ADDENDUM NO. 1 TO PROJECT NO. 45404

**CONSTRUCTION, HVAC, PLUMBING AND ELECTRICAL WORK
PROVIDE BATTALION HEADQUARTERS, BUILDING 75
CAMP SMITH TRAINING SITE
11 BEAR MOUNTAIN BRIDGE ROAD
CORTLANDT MANOR, NY 10567**

August 18, 2016

SHEET TITLE:
 D1/A-201 REVISED ELEVATION- NORTH- NEW

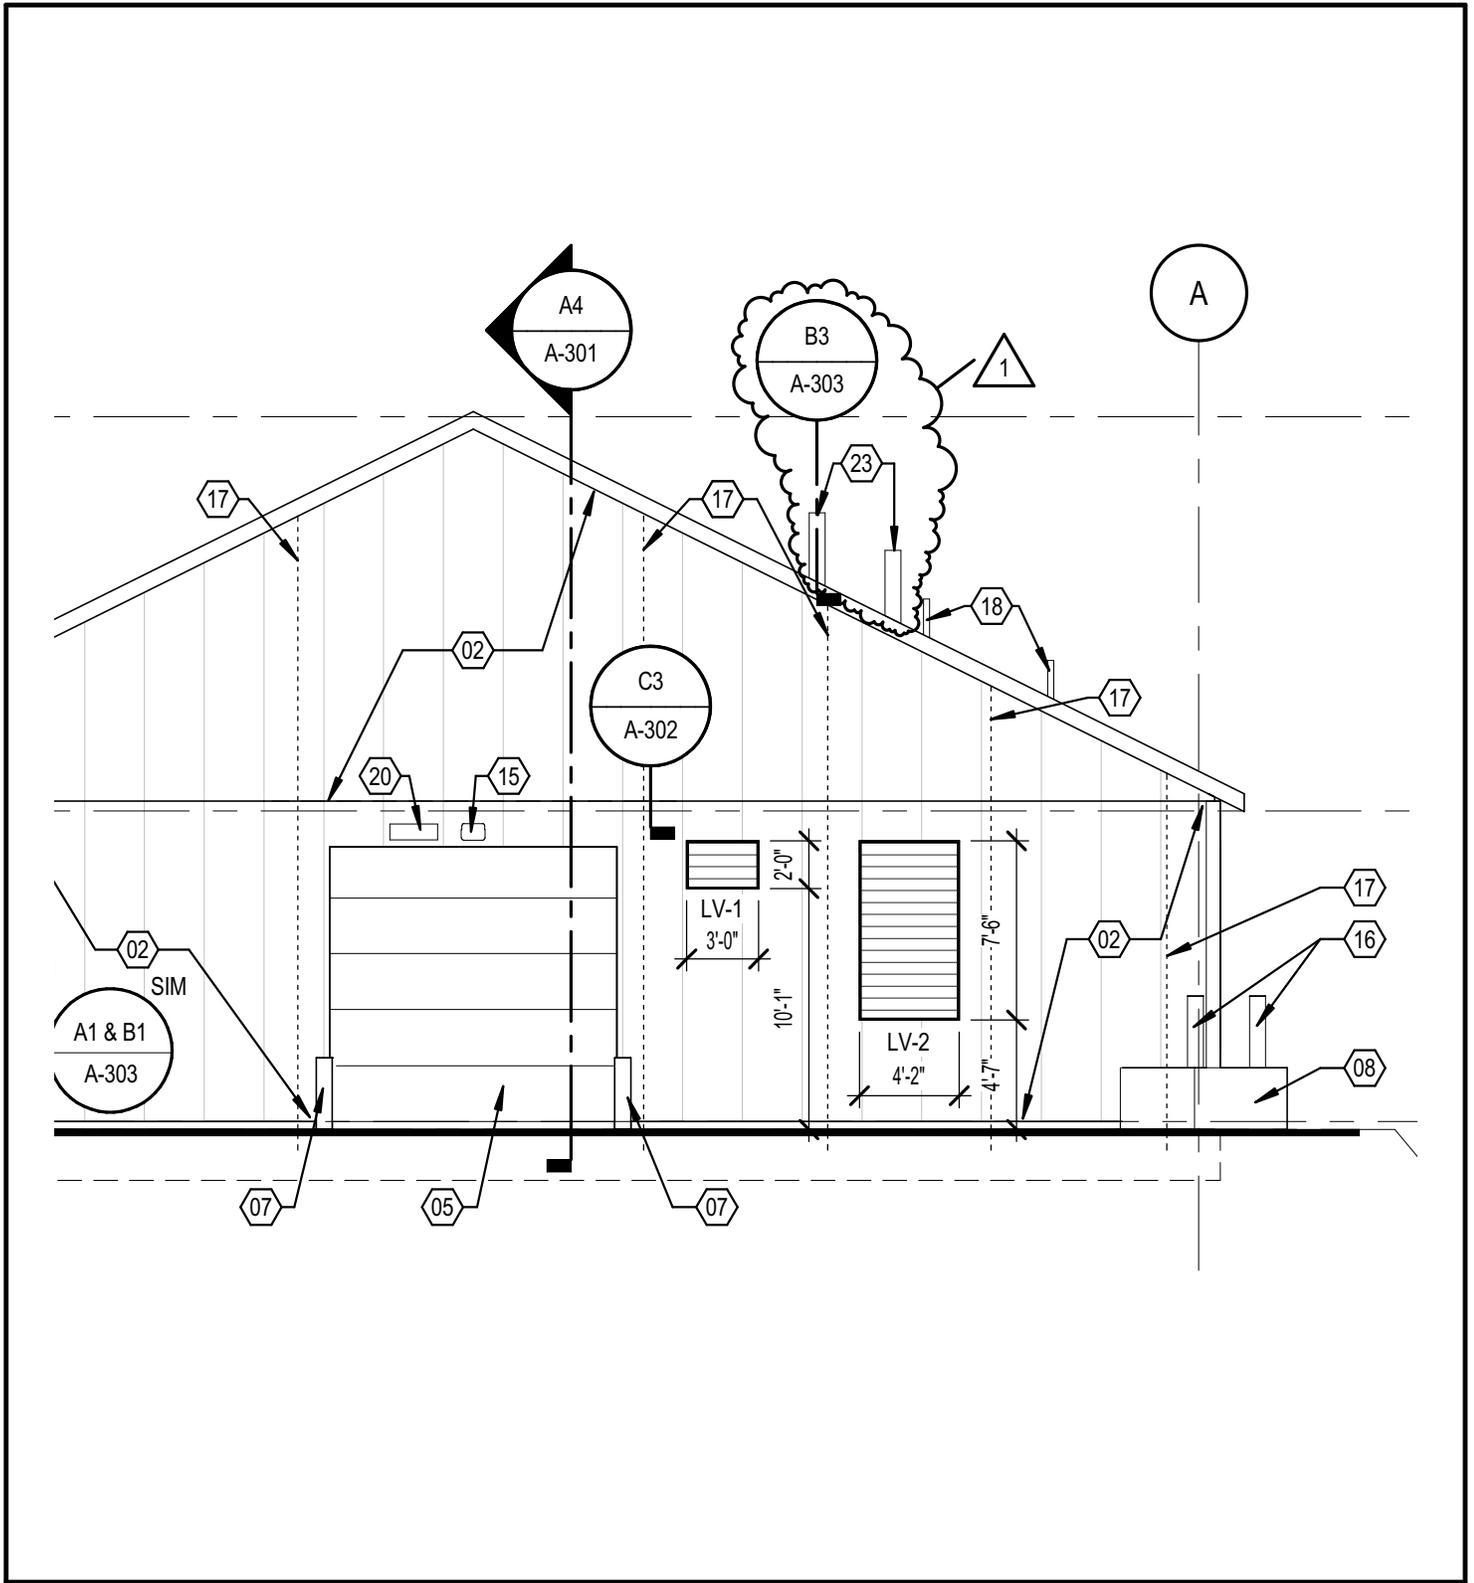
10. Drawing No. A-201:
 - a. Elevation D1; Revise elevation with JD-A24 Addendum Drawing dated 10 Aug 2016.
 - b. Elevation A1; Revise elevation with JD-25 Addendum Drawing dated 10 Aug 2016.

D1

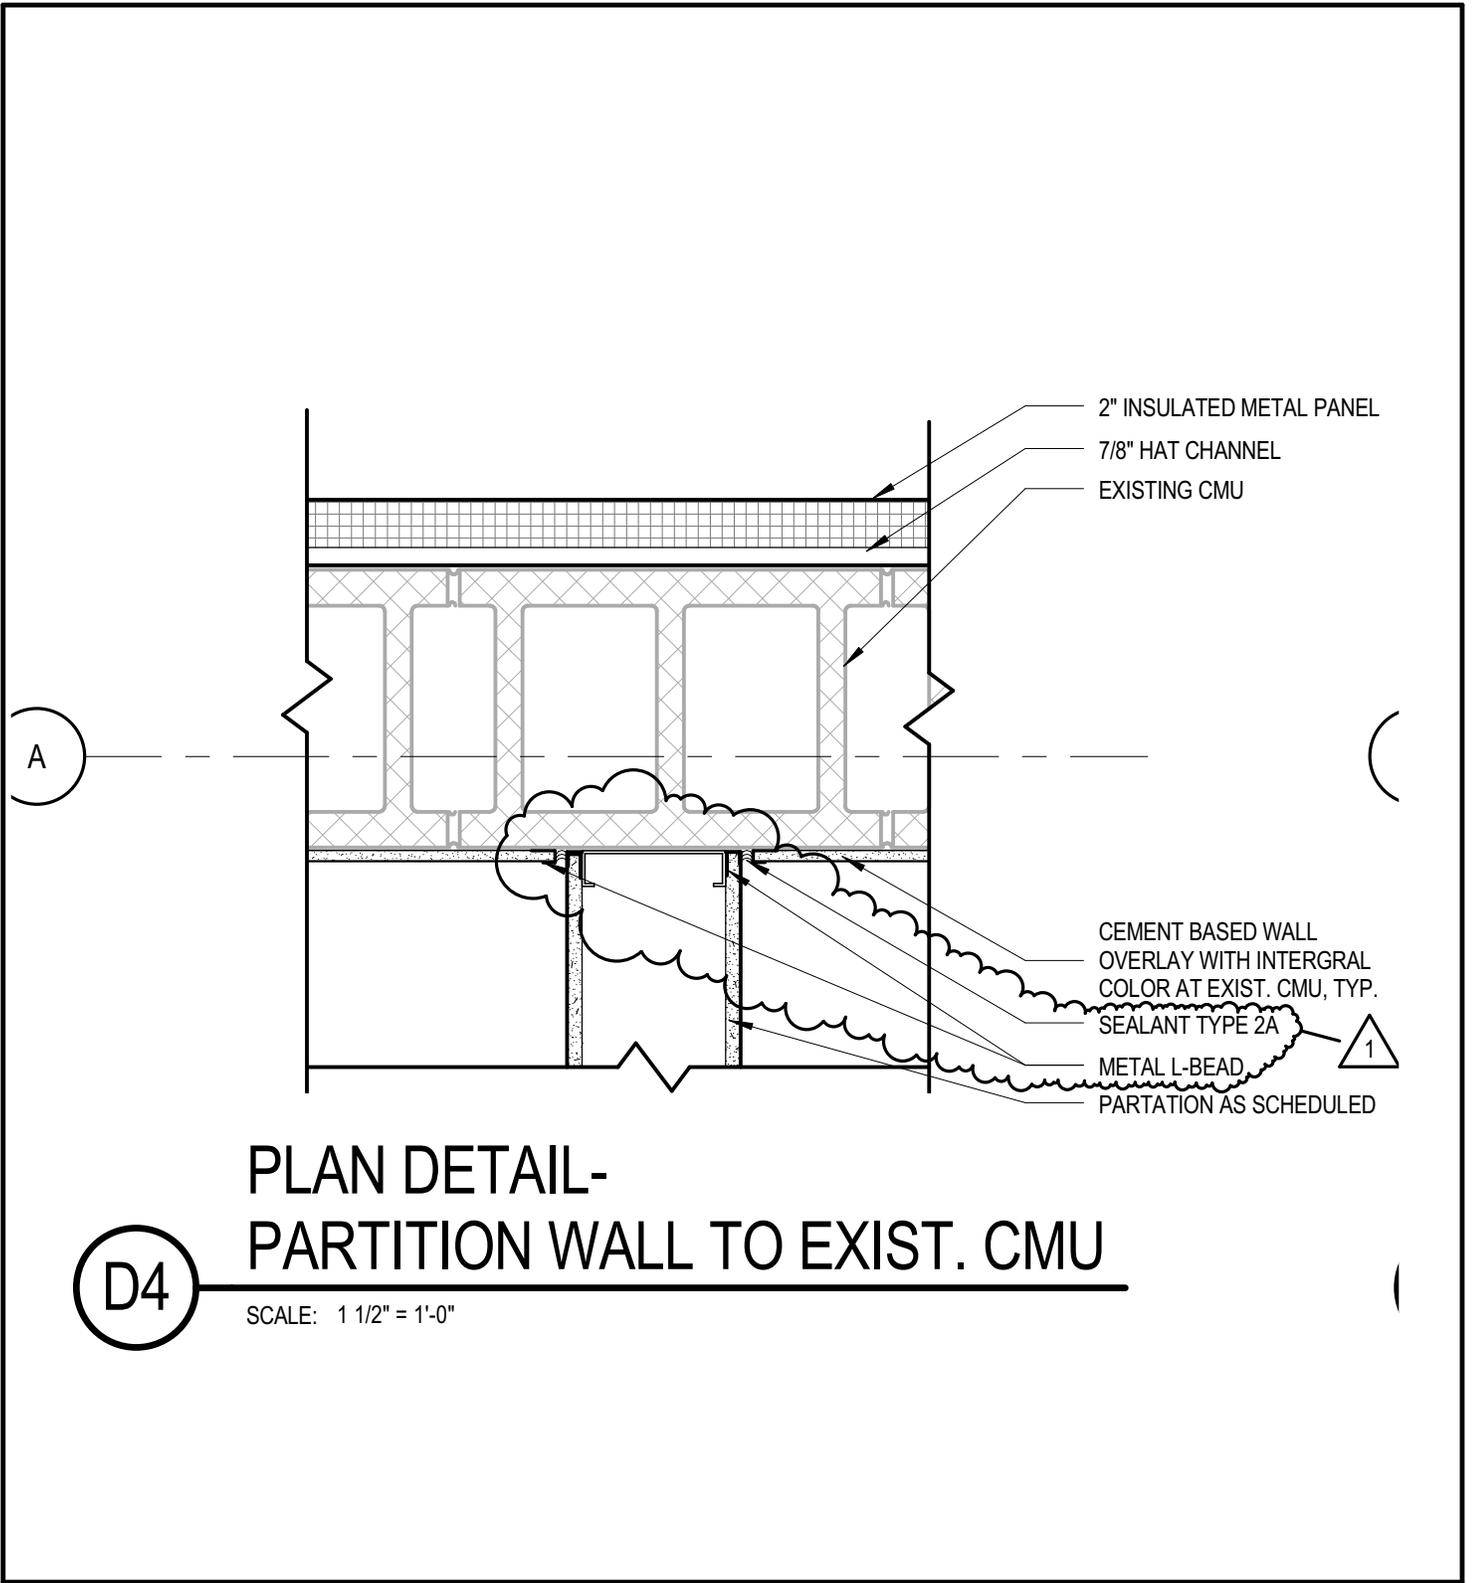
- a. Detail D1; Replace detail with JD-A27 Addendum Drawing dated 10 Aug 2016.
- b. Detail B3; Add detail with JD-A23 Addendum Drawing dated 10 Aug 2016.
- e. Detail D4; Replace detail with JD-A29 Addendum Drawing dated 10 August 2016.
- f. Detail D5; Revise sealant type to read "SEALANT TYPE 1, BOTH SIDES".
